**DOCUMENT 00 90 00
ADDENDUM**

ADDENDUM NO. [1] Date: November 25, 2019

**RE: SOUTHWEST WISCONSIN TECHNICAL COLLEGE
 BOOKSTORE REMODEL
 1800 BRONSON BLVD
 FENNIMORE, WI
 BID NUMBER: 1920-05**

**FROM: HSR Associates, Inc
 100 Milwaukee Street
 La Crosse, WI 54603
 (608) 784-1830**

A100

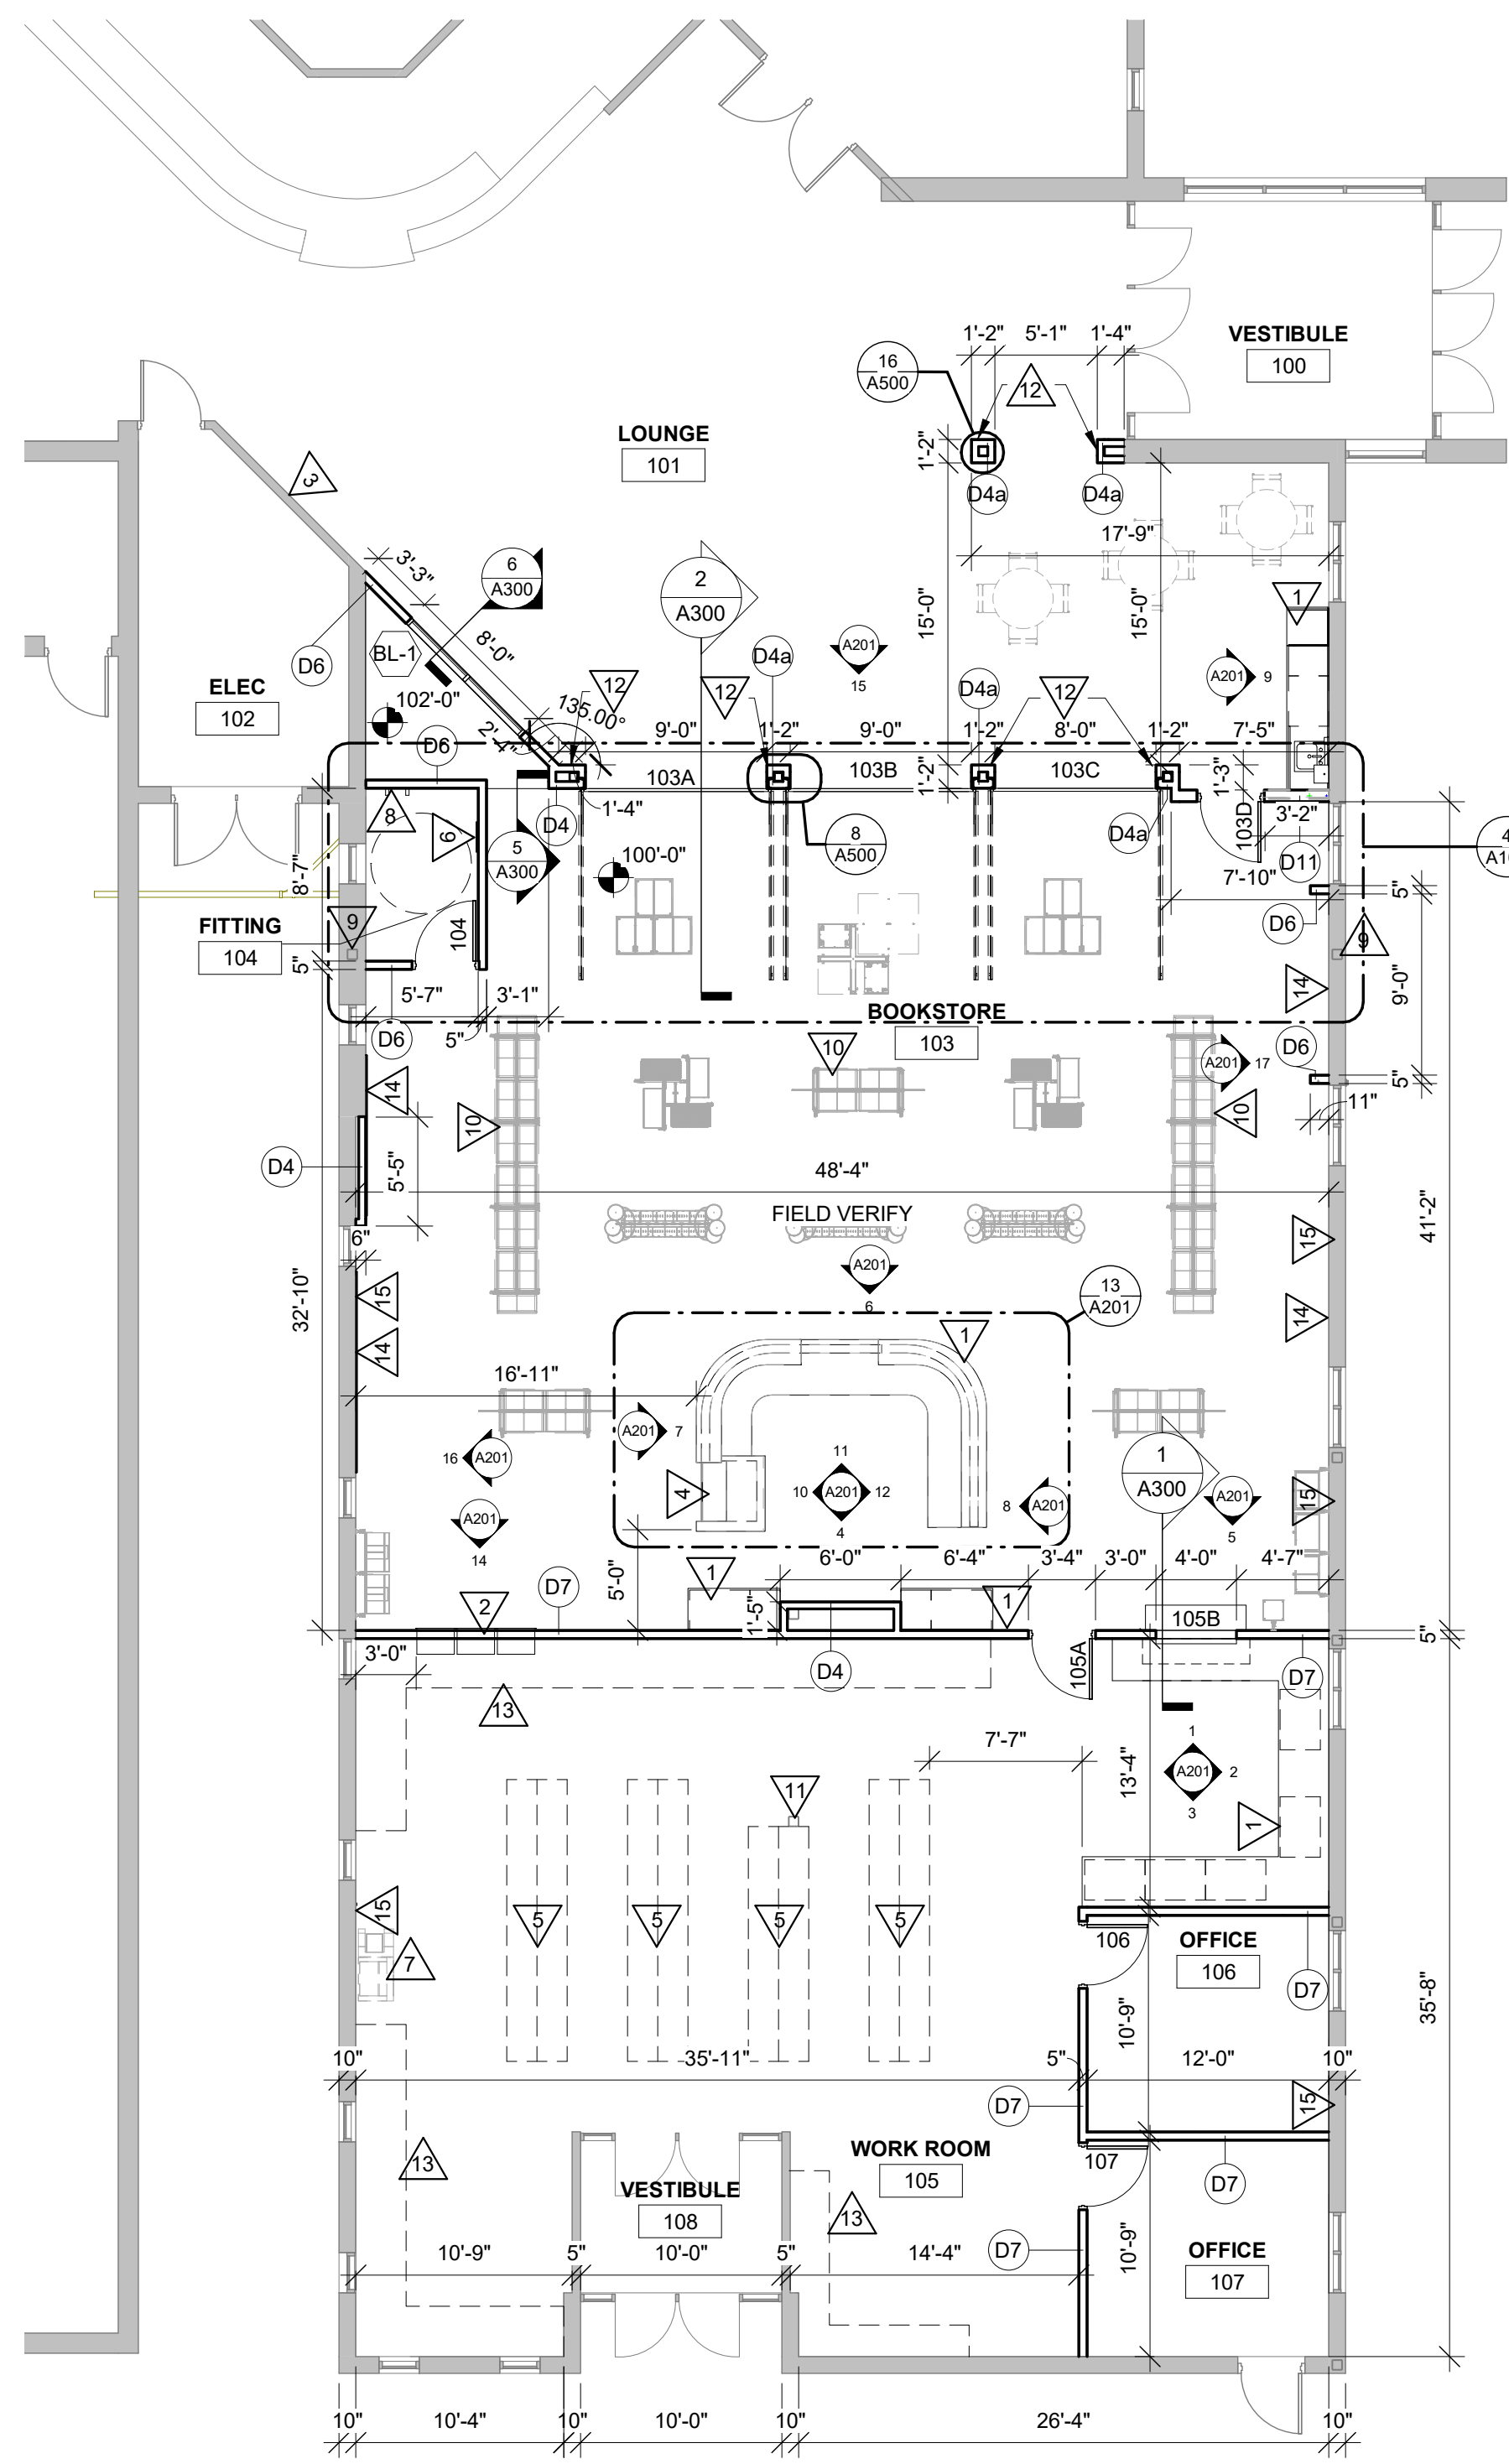
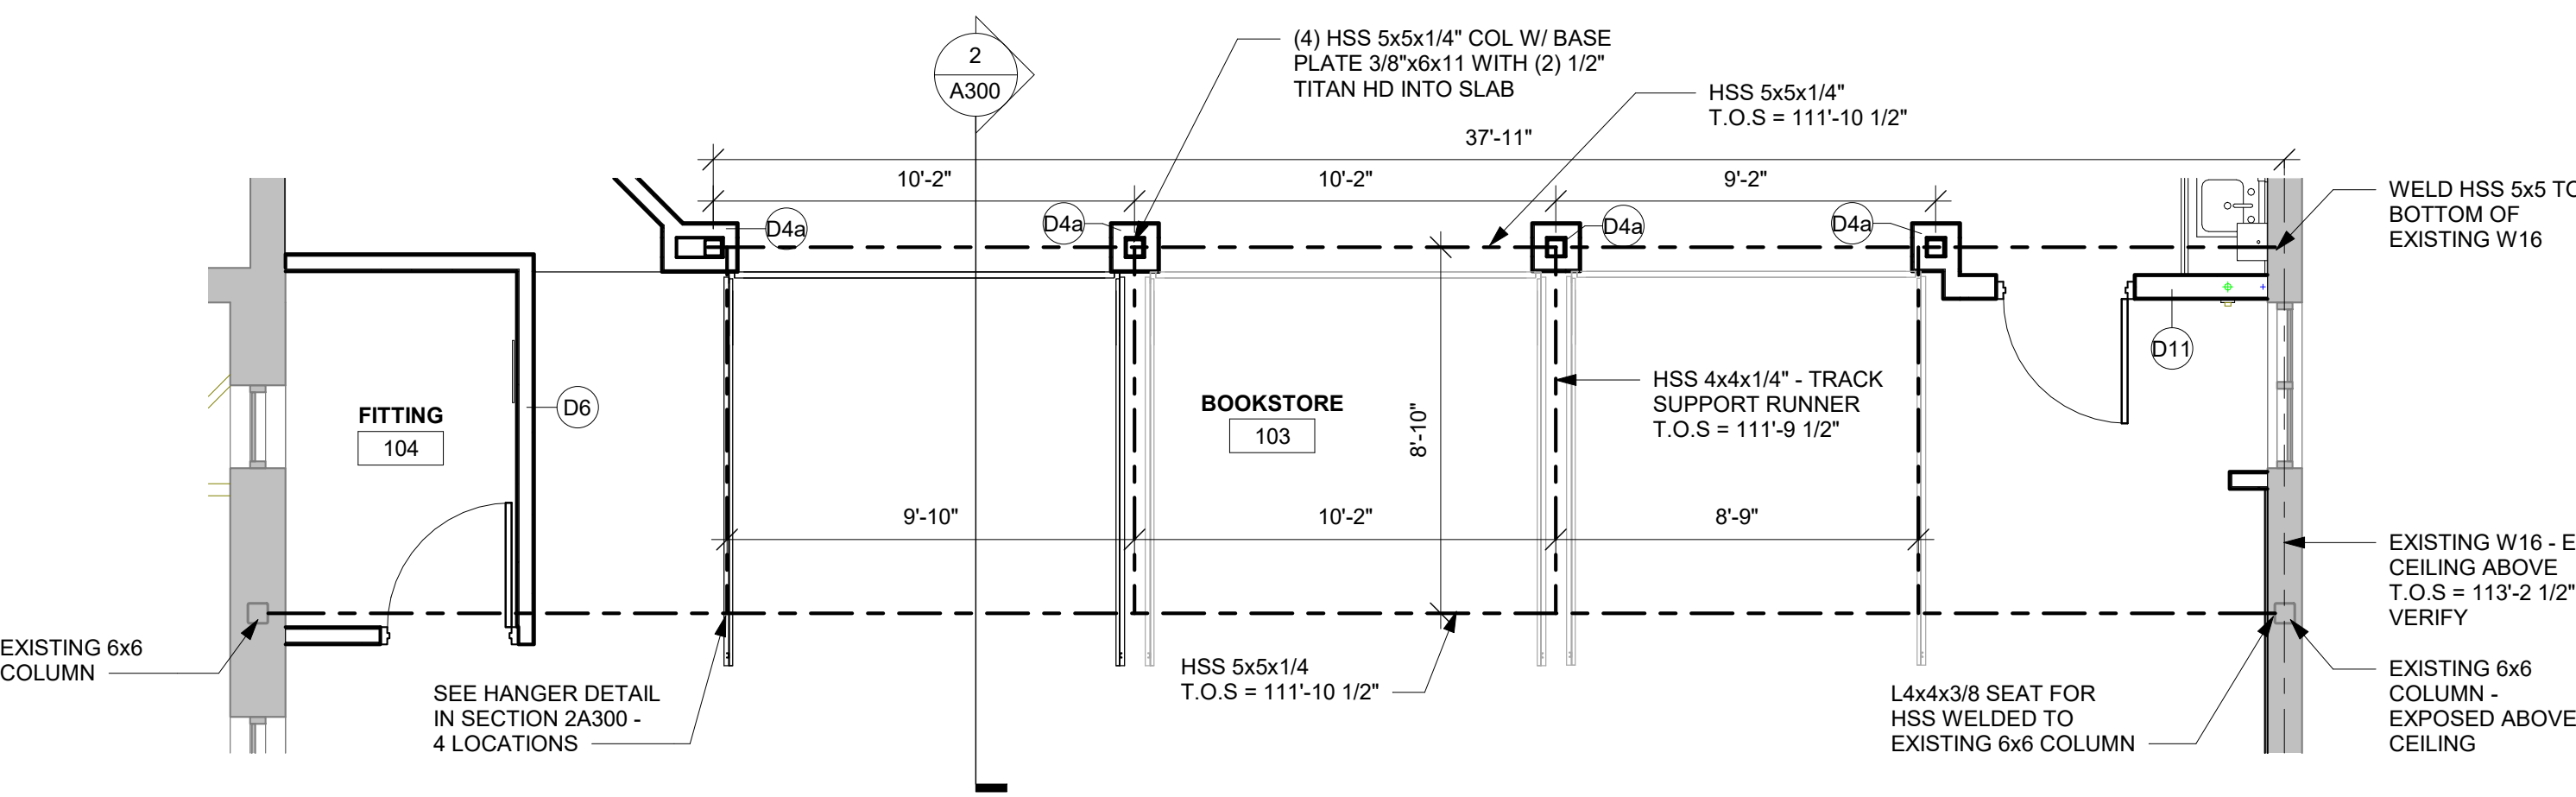
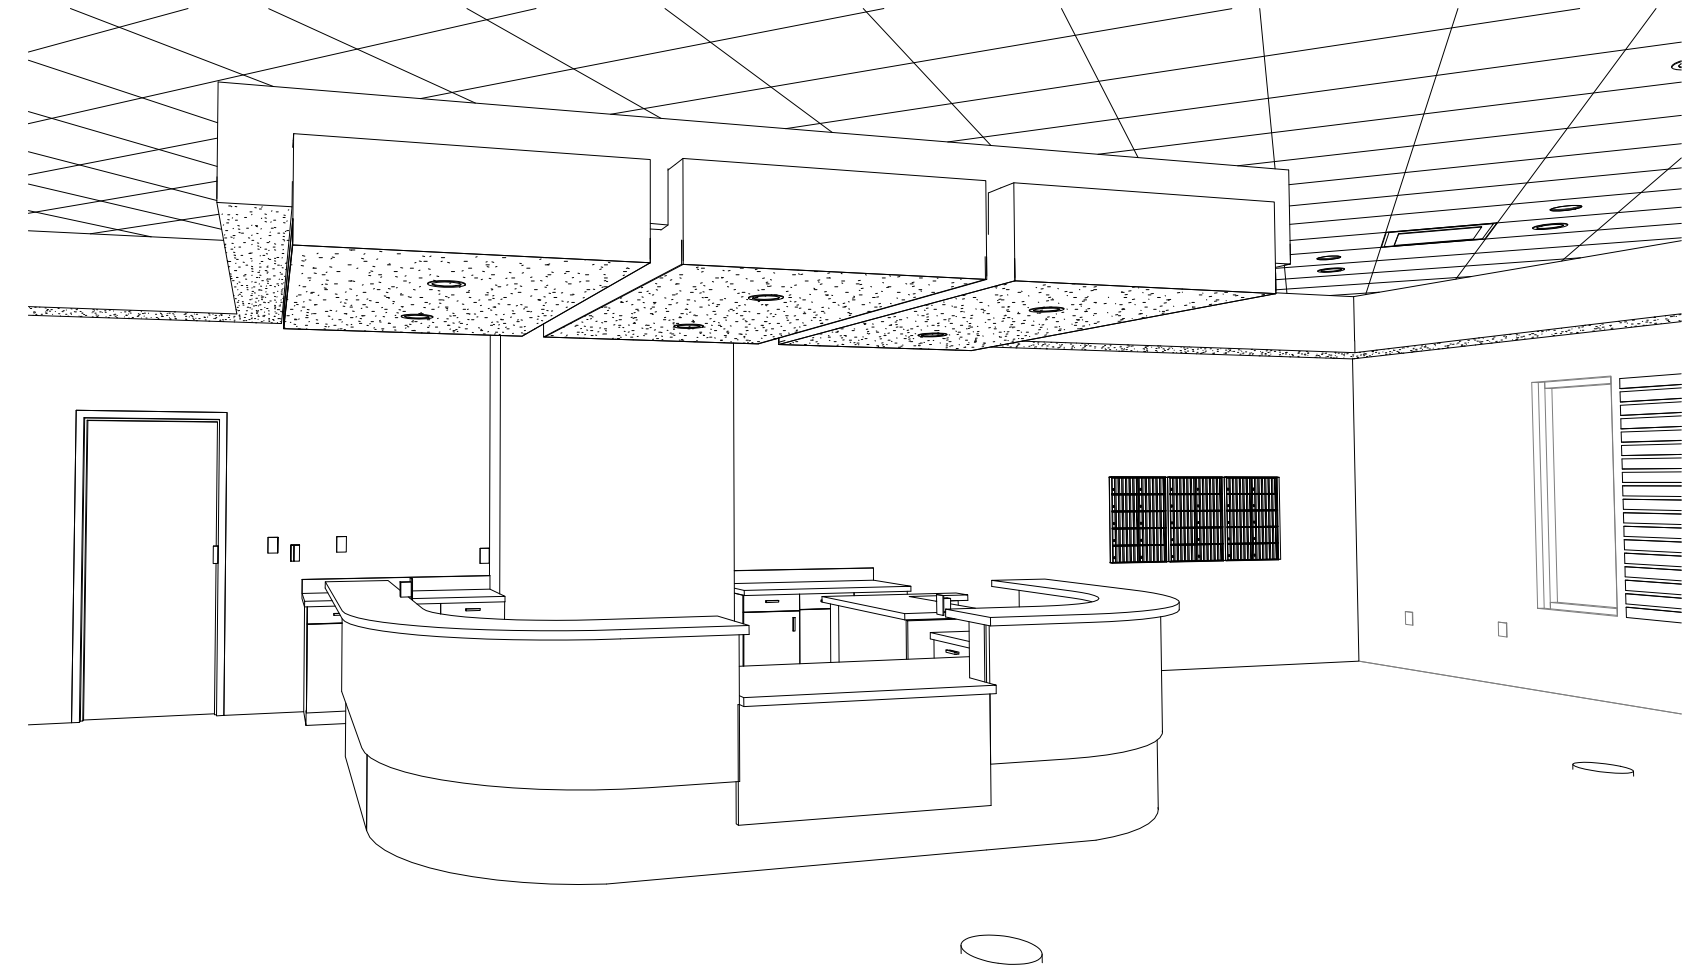
3. Sheet A090 DEMO PLANS 30 x 42 attached hereto
 - a. Revisions clouded on Drawings
4. Sheet A100 REMODEL PLAN AND REFLECTED CEILING PLAN 30 x 42 attached hereto
 - a. Revisions clouded on Drawings
5. Sheet E090 DEMOLITION PLAN 30 x 42 attached hereto
 - a. Revisions clouded on Drawings
 - b. Add note for vestibule handicap access.
 - c. Added junction boxes for power openers.
 - d. Added note for vestibule lighting.
 - e. Added General Note "G".
6. Sheet E200 POWER PLAN 30 x 42 attached hereto
 - a. Revisions clouded on Drawings
 - b. New sound system speakers added (a) and intercom speakers (b) all designated.
 - c. Vestibule card reader new install.
 - d. Add notes for existing Handicap access.
 - e. Added existing junction boxes for handicap power openers
 - f. Modified General Note "H".
